2.8 Revised Scheme

CAMDEN LOCK VILLAGE
 drawing title / location
 Upper Ground Floor Layout - NMA

Stanley Sidings / AHMM / 14045 / R015 / Hawley Wharf Masterplan / July 2015

3.2 Revised Scheme

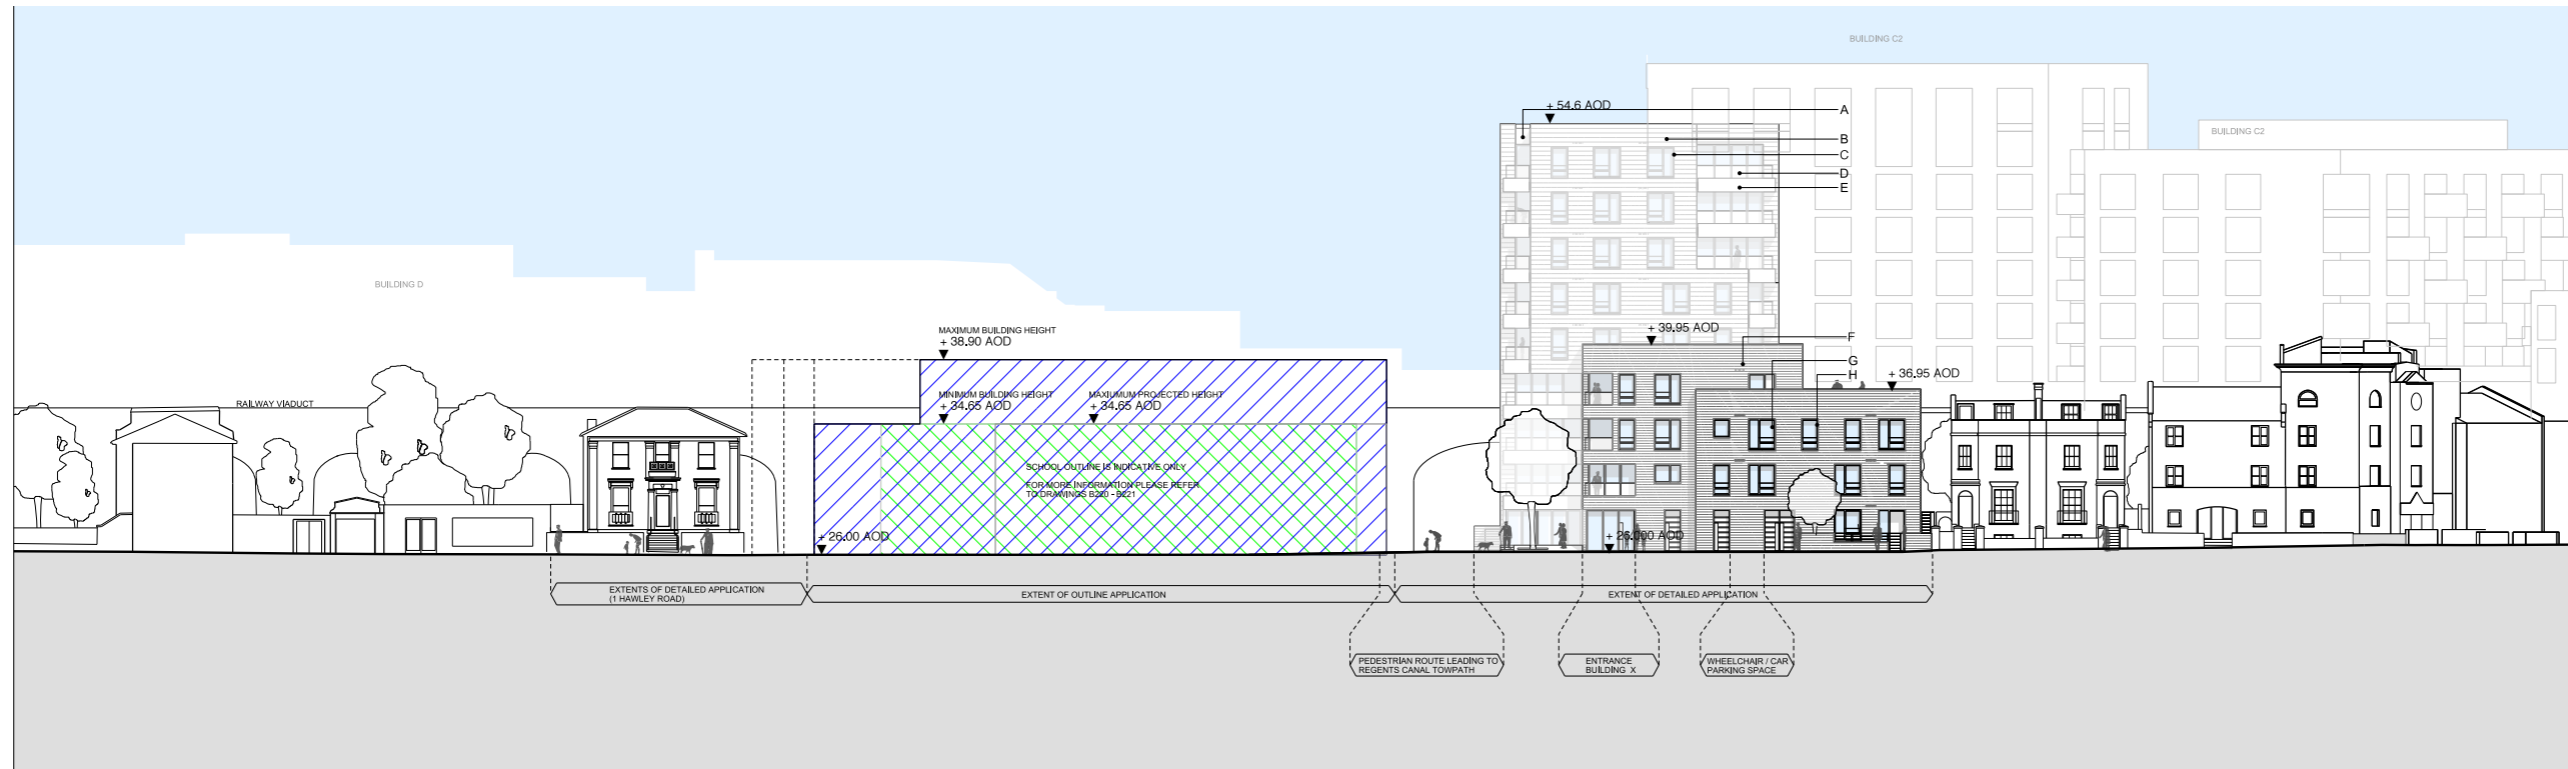
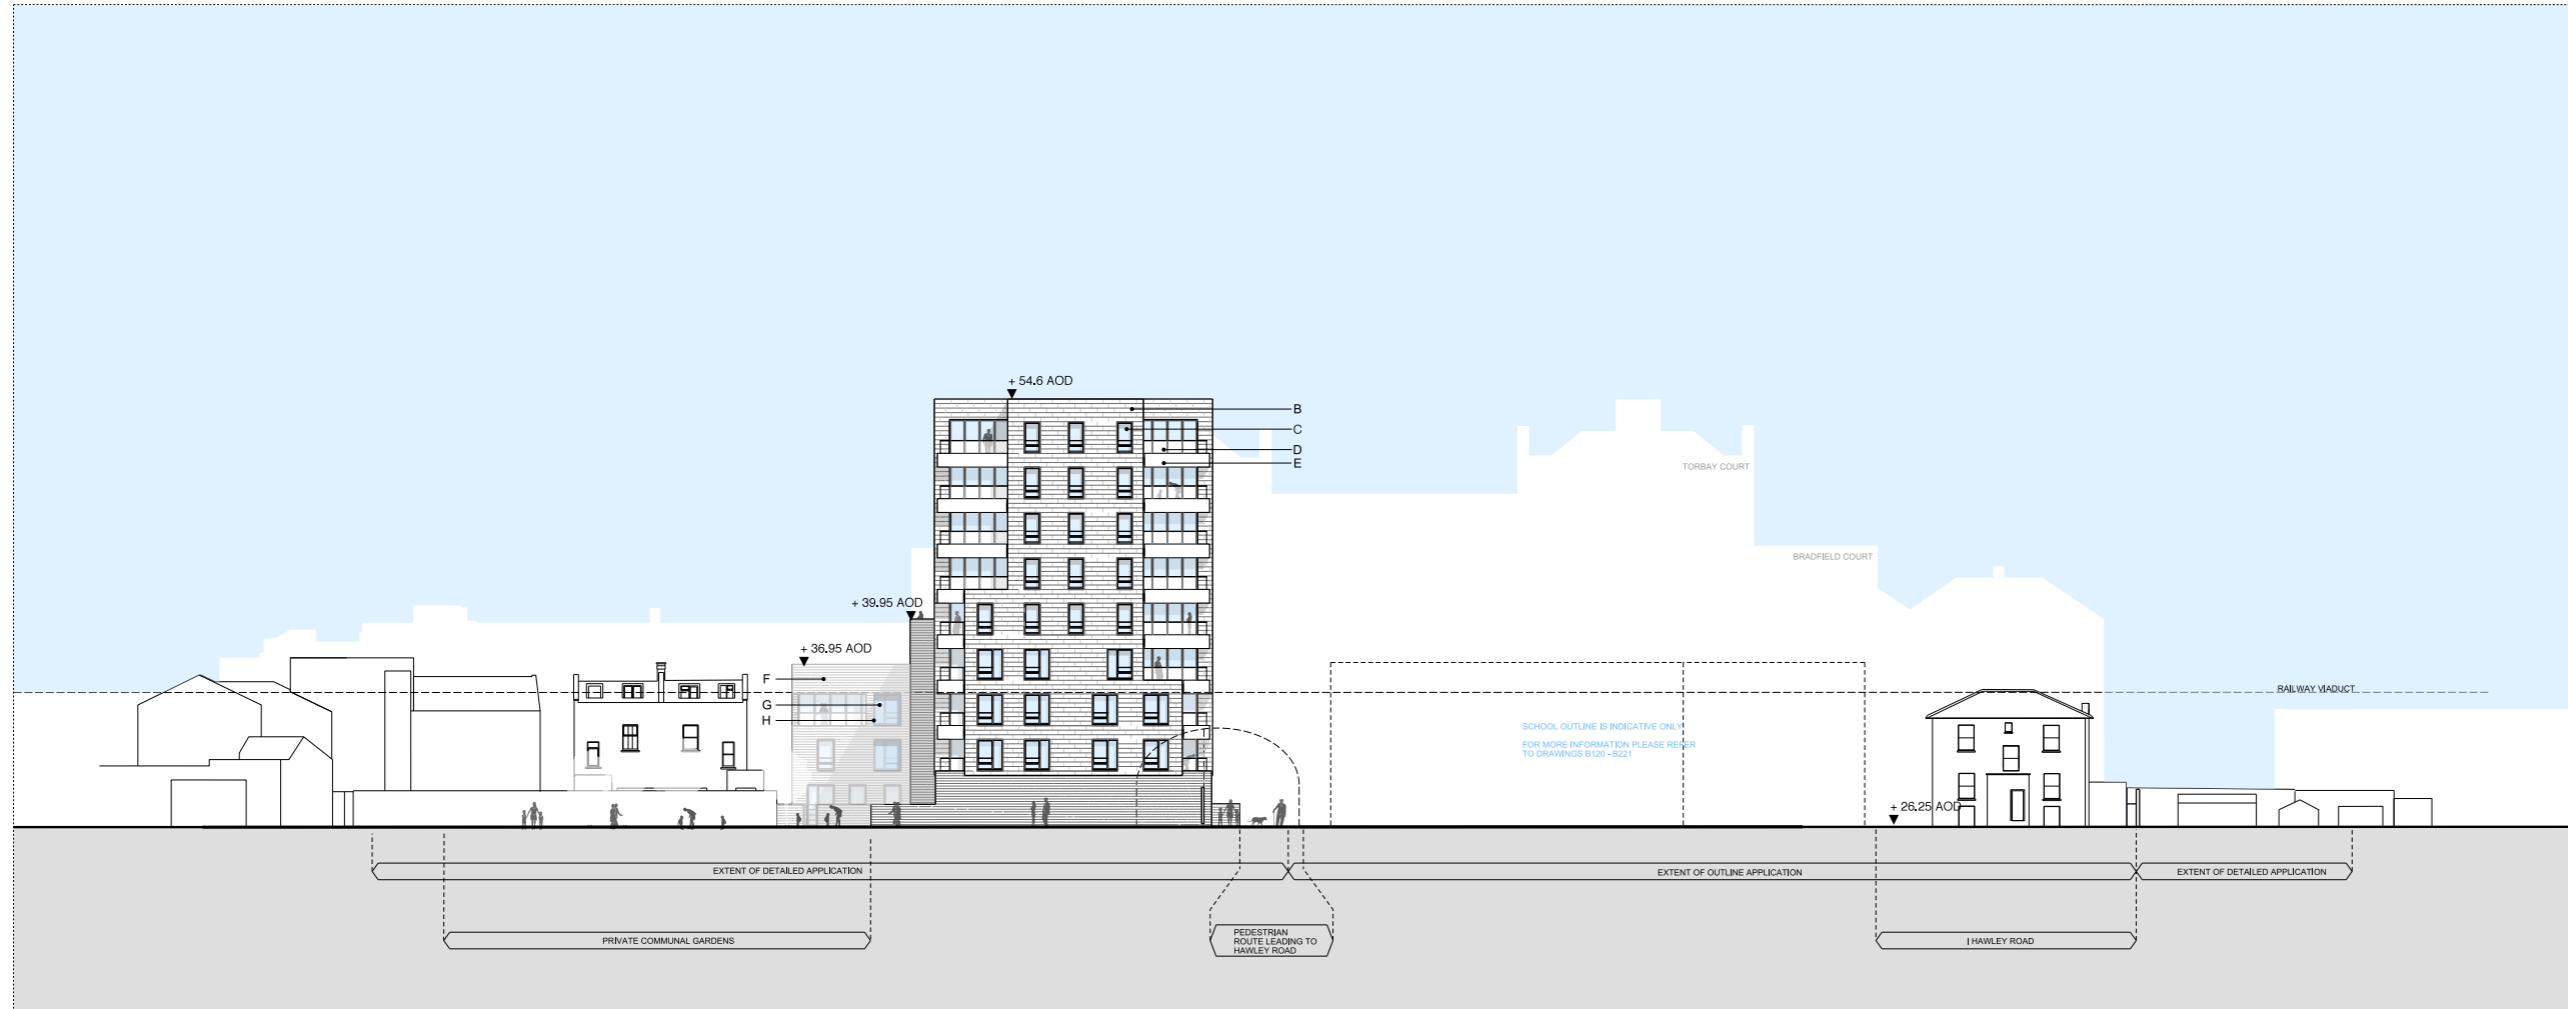
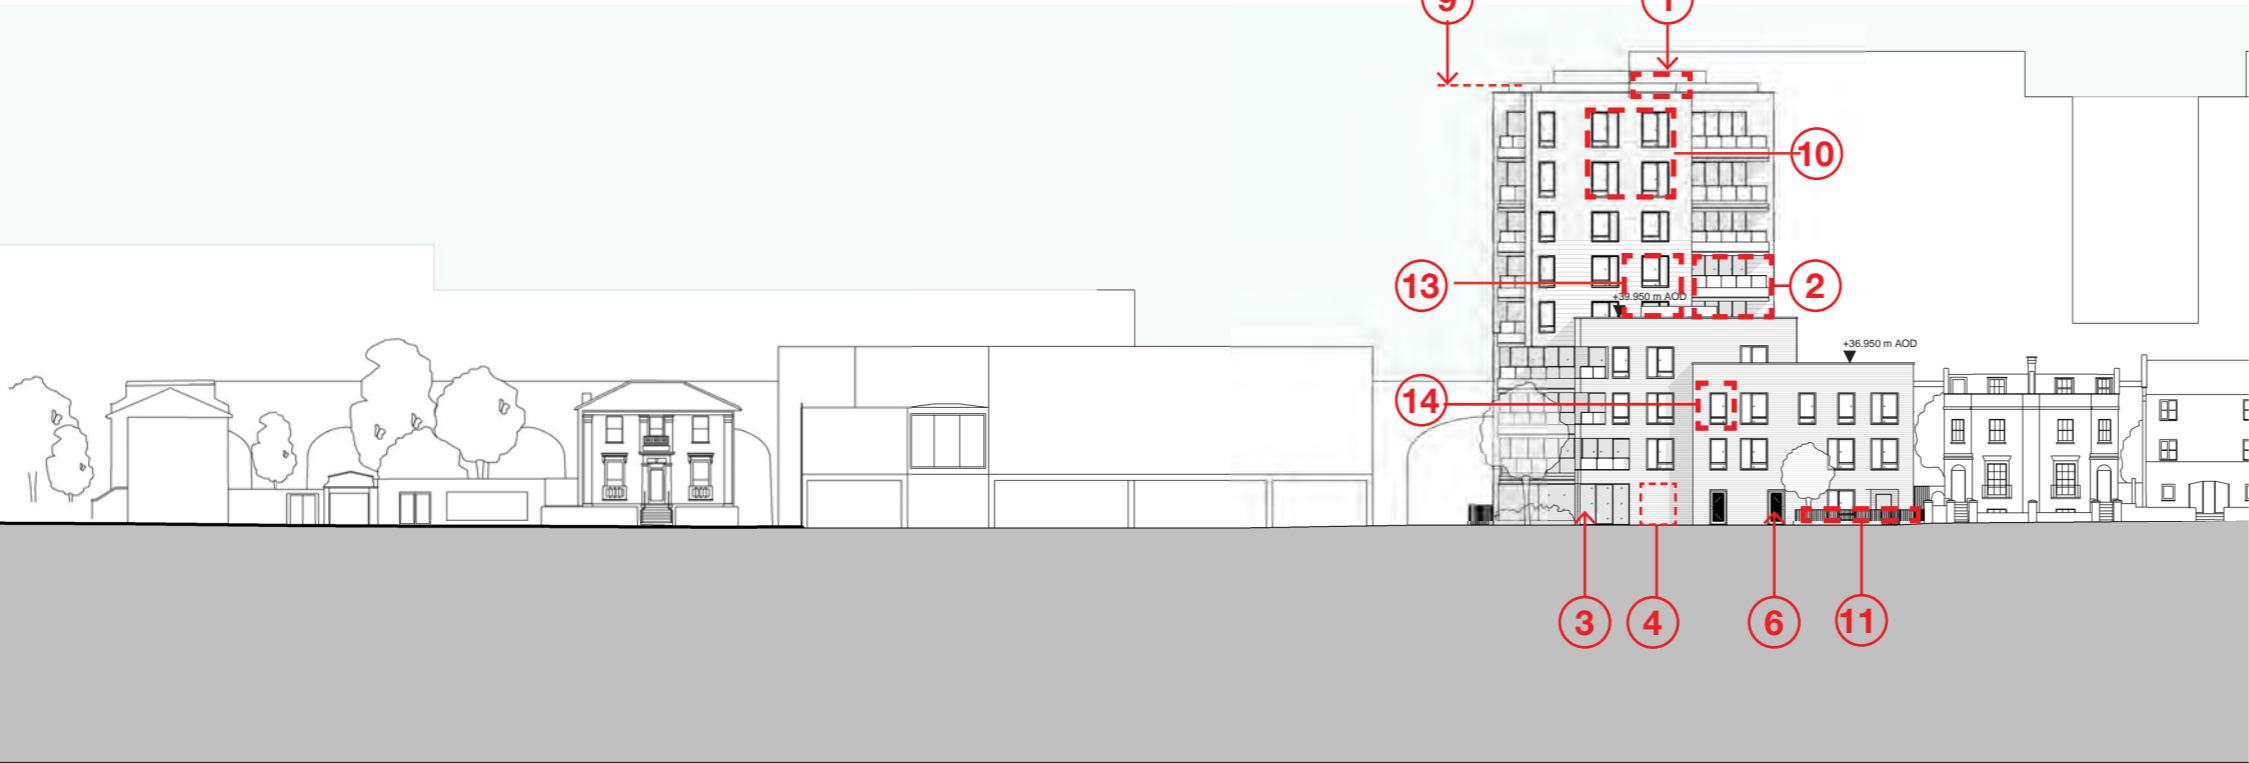
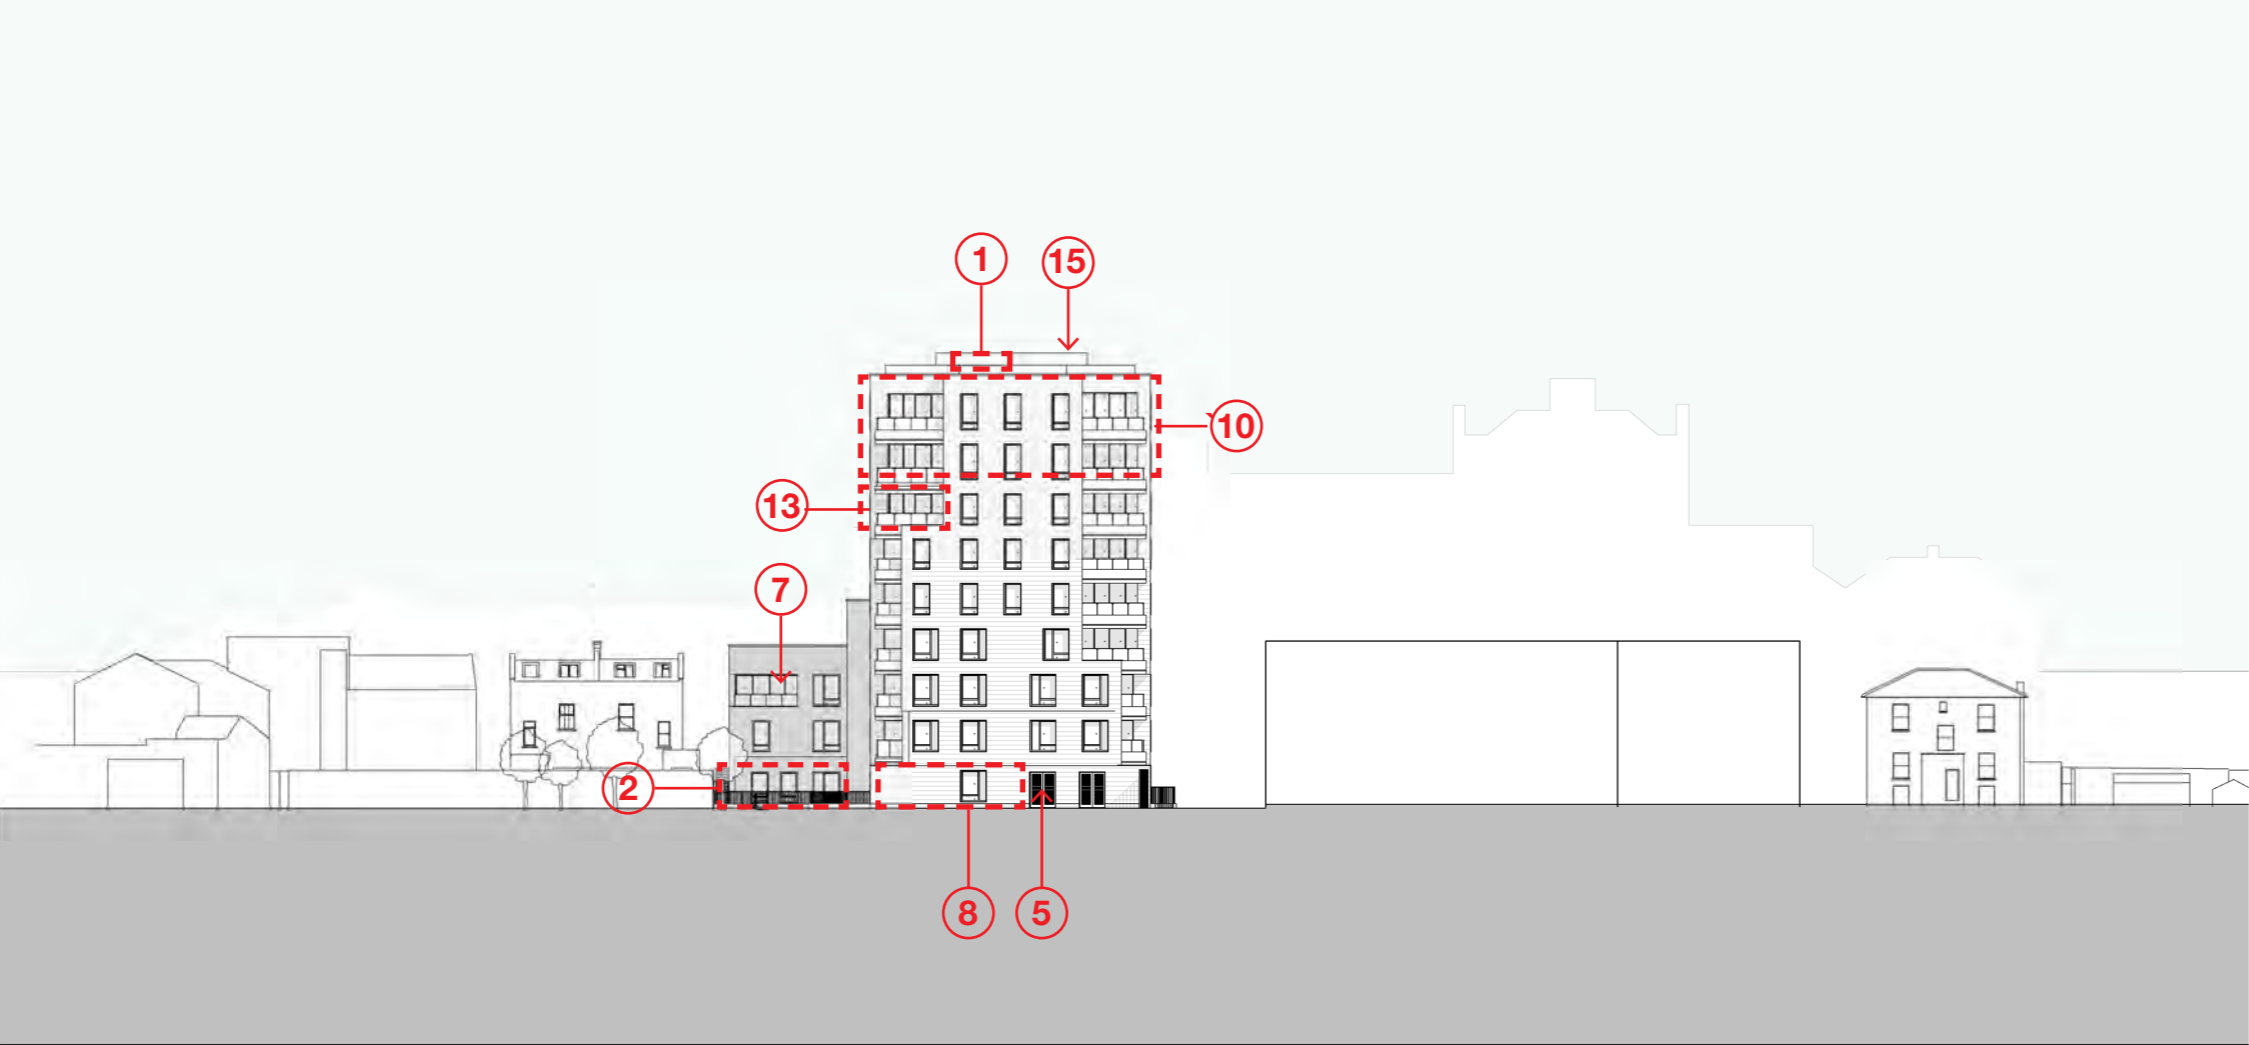
- 1 Lift overrun shown (omitted from approved drawings)
Top of Lift Run: +55.430 AOD
- 2 Windows moved to accommodate structure
- 3 Entrance recessed by 1200mm to comply with Lifetime Homes criterion 4

- 4 Door removed due to relocation of plant room
- 5 New metal louvred door added for plant access
- 6 Door amended to accommodate cycle store behind
- 7 Balcony width reduced to accommodate structure

- 8 New opening added to provide dual aspect for apartment overlooking viaduct.
- 9 Parapet Level increased by +300mm (+54.900M) to hide roof plant
- 10 Glazing increased by 300mm on the top two floors.
Increased glazing height: 2700mm

- 11 Brick fencing wall replaced with metal railing
- 12 New metal louvred fixed panel added for plant ventilation behind
- 13 Balconies orientation reconfigured

- 14 Window enlarged to match the internal layout change
- 15 Satellite dish locations - maximum 1800mm diameter
